Comments on Eversource's Application to Easton for a Conditional Use Permit for damages to wetlands.

Comment for SEC 2024-02,  
DE-24-087 and the Easton  
Planning Board and ZBA

kris pastoriza

January 14, 2025

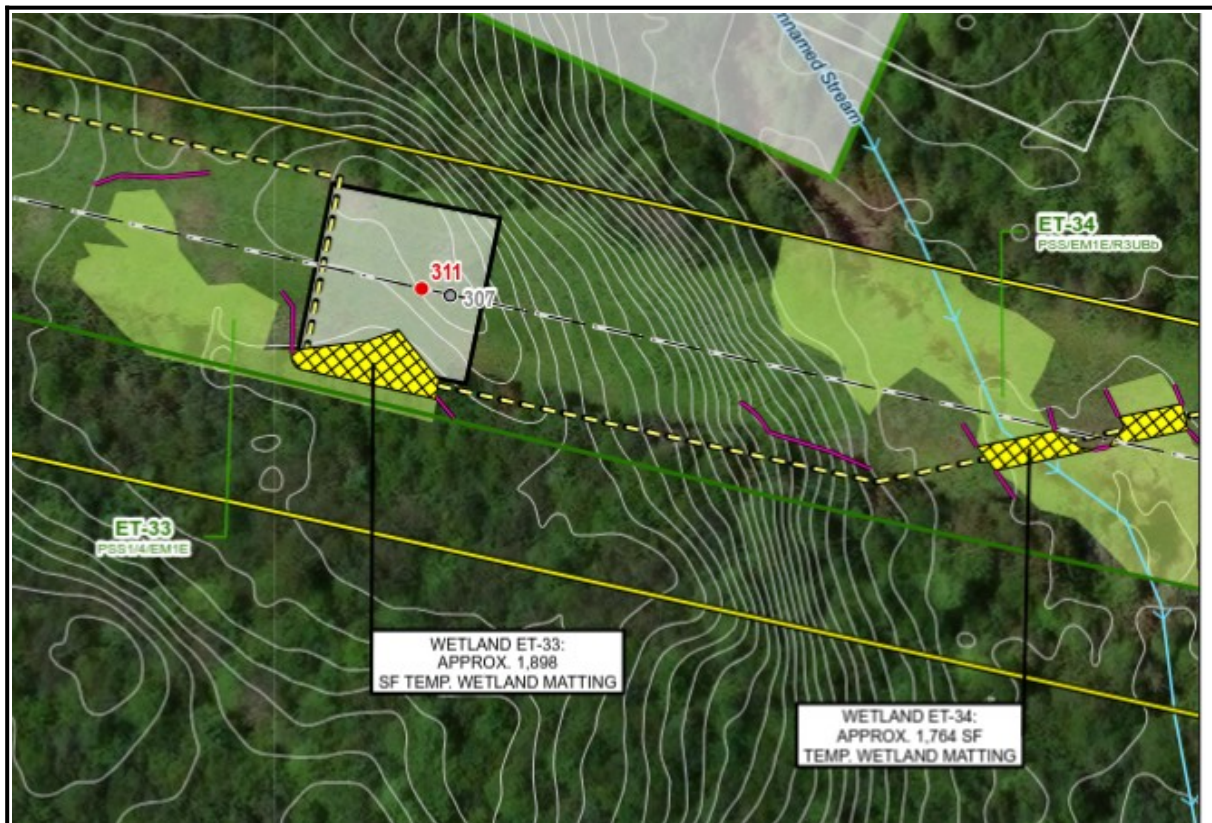
Eversource fails to mention that NHDES Alteration of Terrain Bureau has not approved the AoT or Standard Dredge and Fill Wetlands permits for the X-178 (2) Phase 2 and the Town of Easton and easement-encumbered landowners have not received these permit and permit waiver applications.

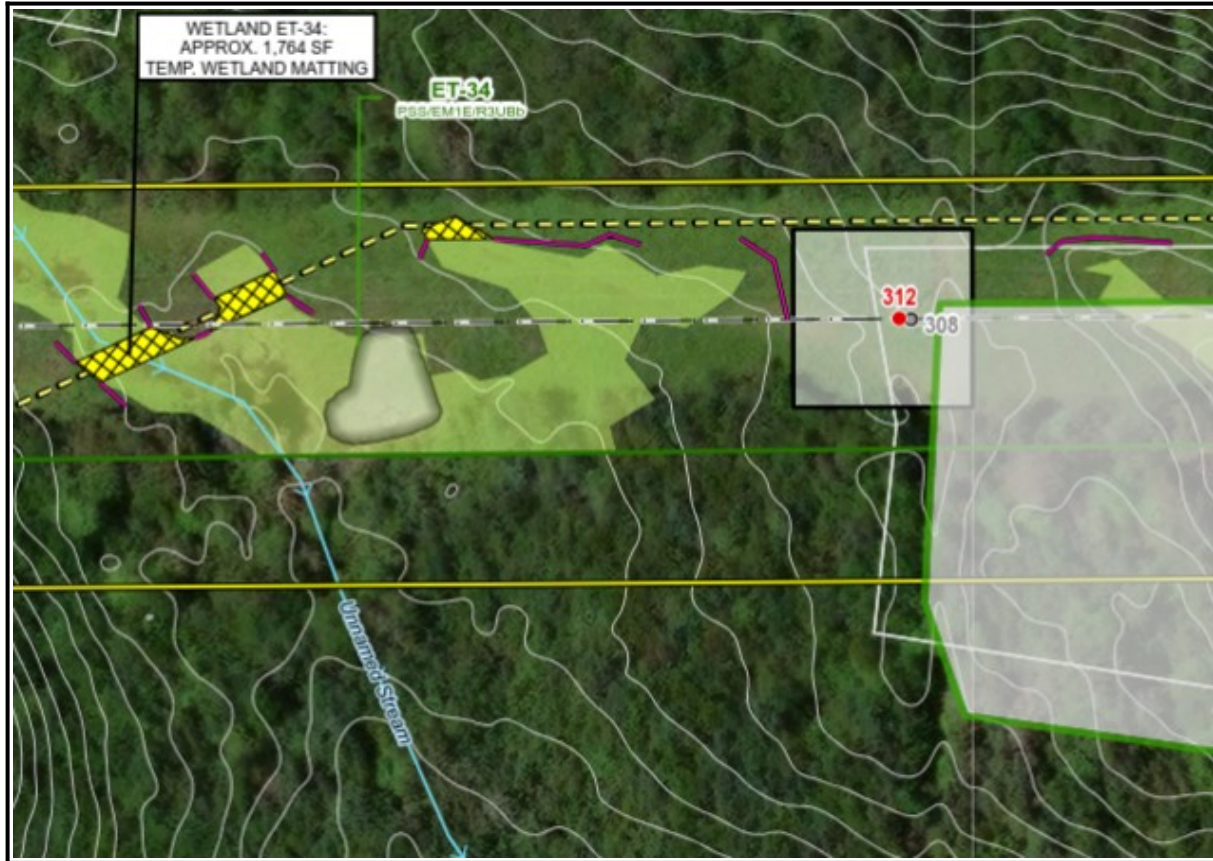
Above: Map 8. Delineation of Local Wetland Buffer is missing.

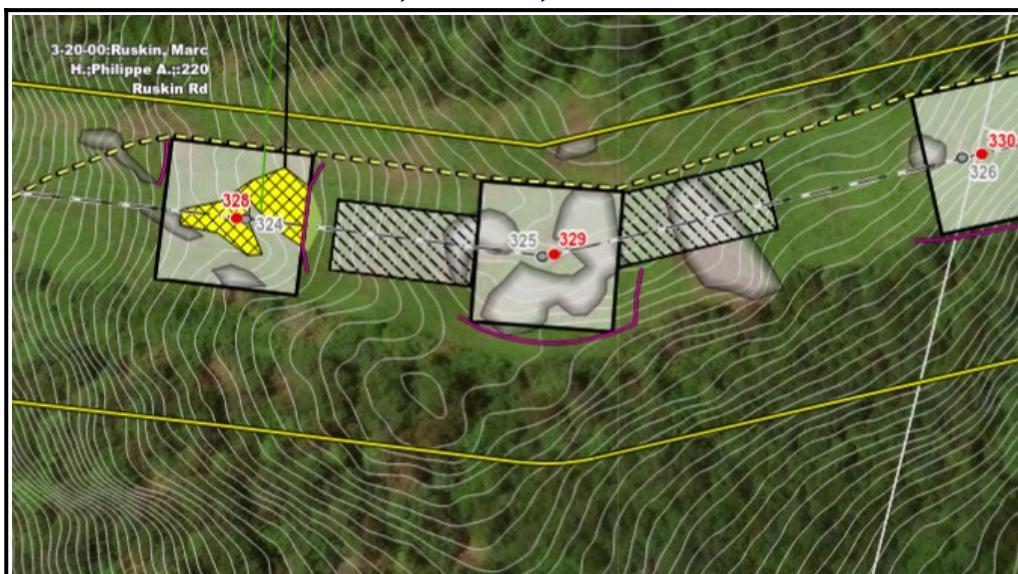
Map 14. This map shows ledge, most especially at the height of land from which there is a beautiful view of Moosilauke, Mt. Blue, Beech Hill and the Kinsmans. This area used to be

pasture, likely part of the Samuel Cole Farm. The ledge is a natural feature with cultural and ecological value and I suggest you act in accordance with Easton’s Master Plan and do not destroy it. View shown below:

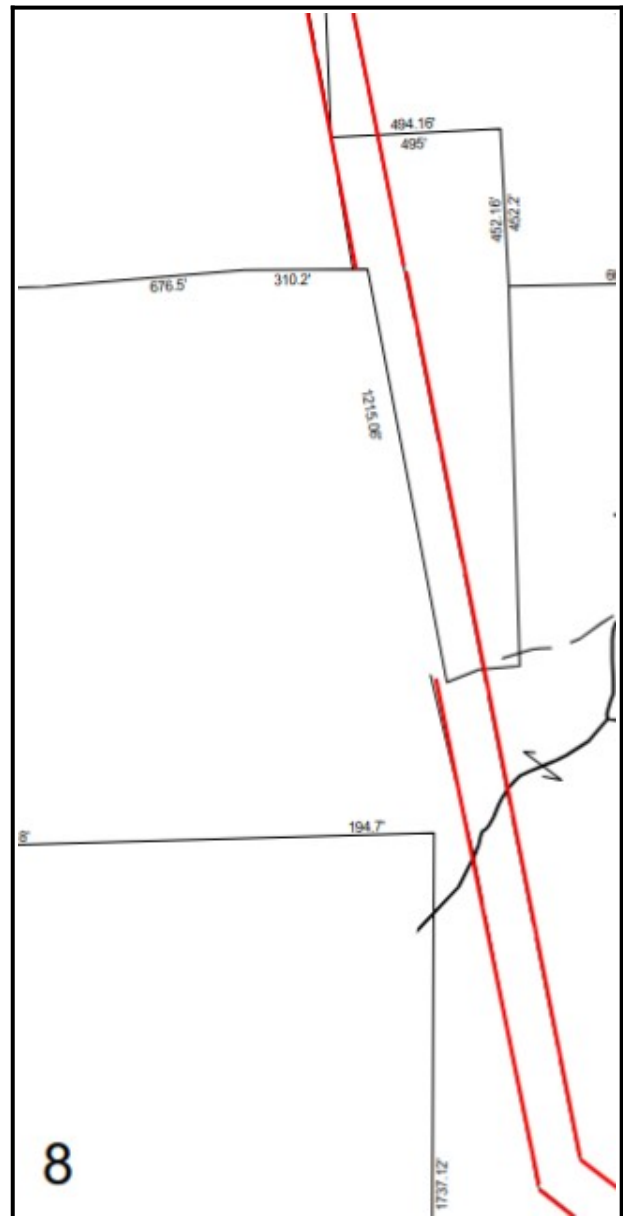
The tax map is outdated and inaccurate. The easement boundary is the property line in the map right:
